**Rezoning Application: PD 24-1202****Zoning Hearing Master Date:** May 19, 2025**BOCC Land Use Meeting Date:** July 22, 2025**Hillsborough  
County Florida**

**1.0 APPLICATION SUMMARY****Applicant:** Todd Pressman**FLU Category:** CMU-12**Service Area:** Urban**Site Acreage:** 2.97 acres**Community  
Plan Area:** East Lake/Orient Park**Overlay:** None**Introduction Summary:**

## AGENCY REVIEW COMMENT SHEET

PETITION NO: PD 24-1202

PD Variations to buffering and screening (Option 1): Principal use of a site for open storage requires buffering of the entire site as a Group 6 use.

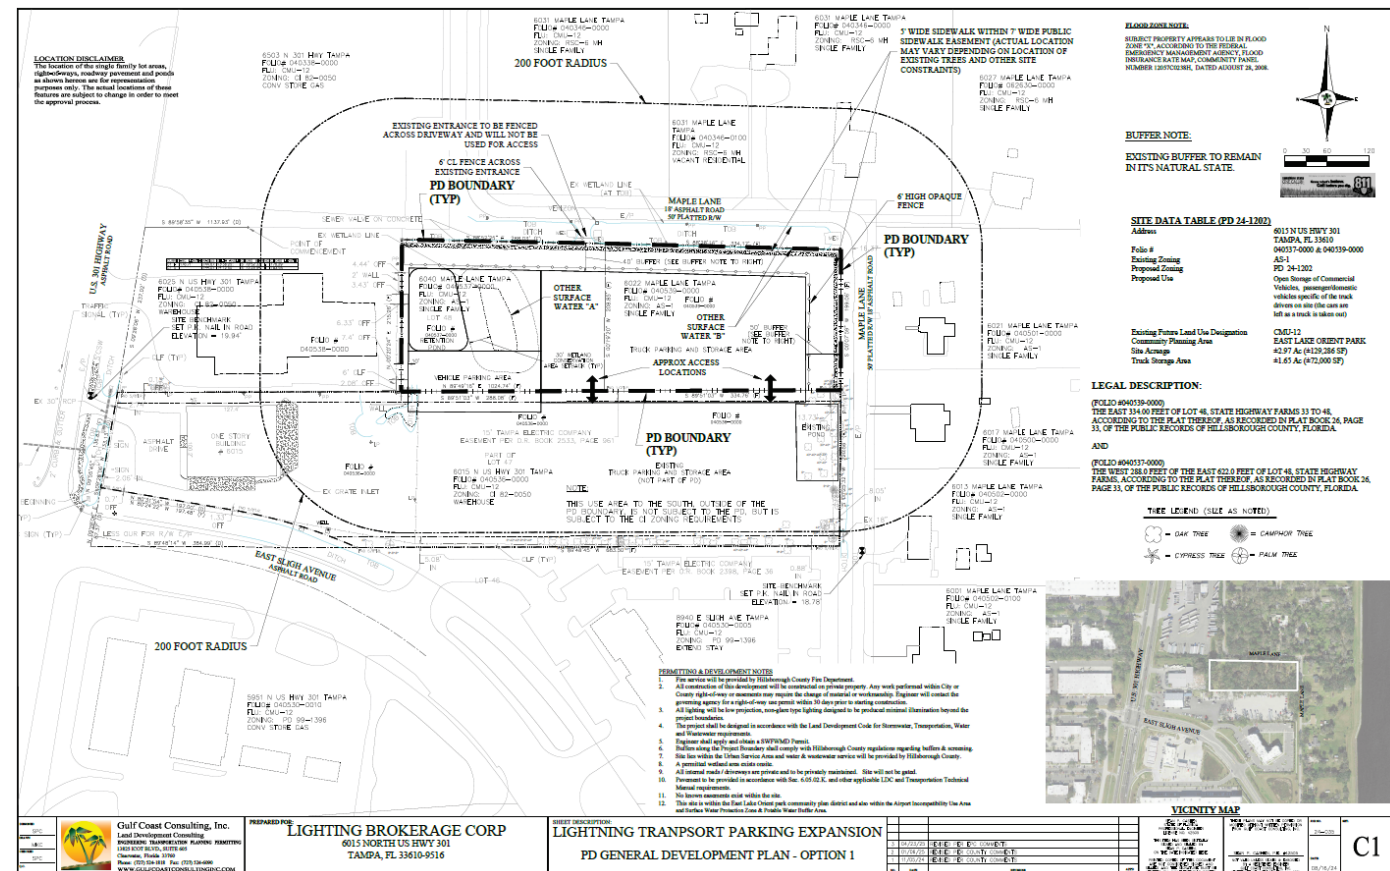
1. North: 30-foot-wide buffer with Type C screening required. The applicant proposes to enhance the buffer to 40 feet. Type C screening will be provided, except the masonry wall is to be replaced by a wood or PVC fence.
2. East: 30-foot-wide buffer with Type C screening required. The applicant proposed to enhance the buffer to 50 feet. Type C screening will be provided, except the masonry wall is to be replaced by a wood or PVC fence.

1. Screening provided along Maple Lane (North/south segment) to provide the required screening at least 100 feet in the site from the street line. The applicant proposes to provide screening only along the street frontage.

## 8.0 PROPOSED SITE PLAN (FULL)

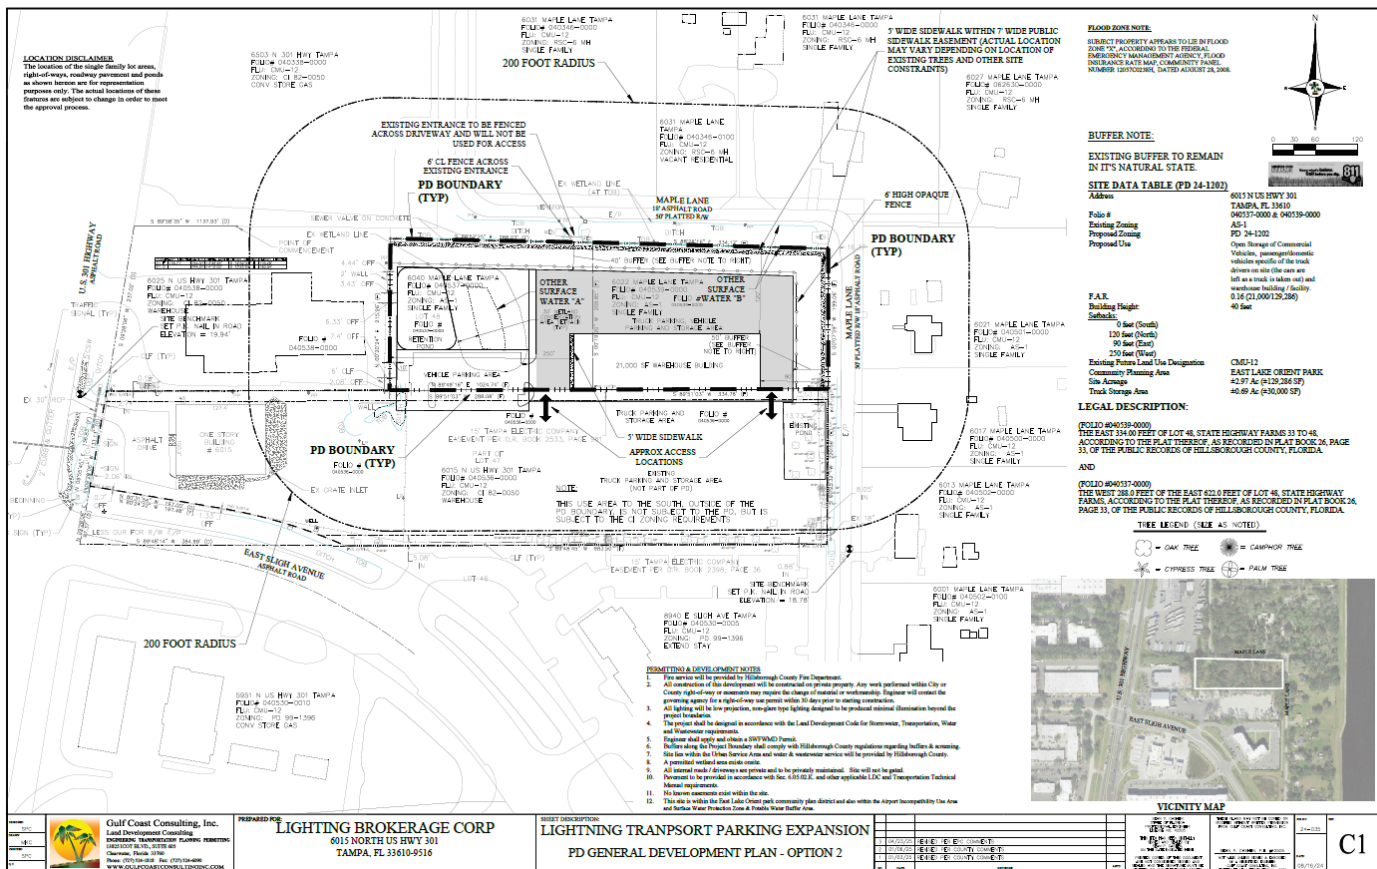
- Prior to PD site plan Certification, the developer shall revise the site plan to:
  - Modify the label reading “6’ CL Fence Across Existing Entrance” to instead read “Access to be Removed or Restricted – See Conditions of Approval”.

The project has an existing access connection to Maple Ln. which the applicant is proposing to fence off rather than remove. Staff reviewed this with the County Engineer who does not support such proposal. Staff notes that discontinued access connections are required to be removed and ditches restored, which helps avoid unnecessary and costly ditch maintenance and the removes a pipe which has the possibility of clogging and flooding surrounding areas during storm events. Staff also notes that “phantom driveways” can also confuse drivers, and lead to people trying to turn in where a driveway does not exist. Staff has proposed a condition which allows this connection to remain if necessary as a gated emergency access, otherwise the connection shall be removed.

1. Prior to PD site plan Certification, the developer shall revise the site plan to:
  - a. Modify the label ready "6' CL Fence Across Existing Entrance" to instead read "Access to be Removed or Restricted – See Conditions of Approval"
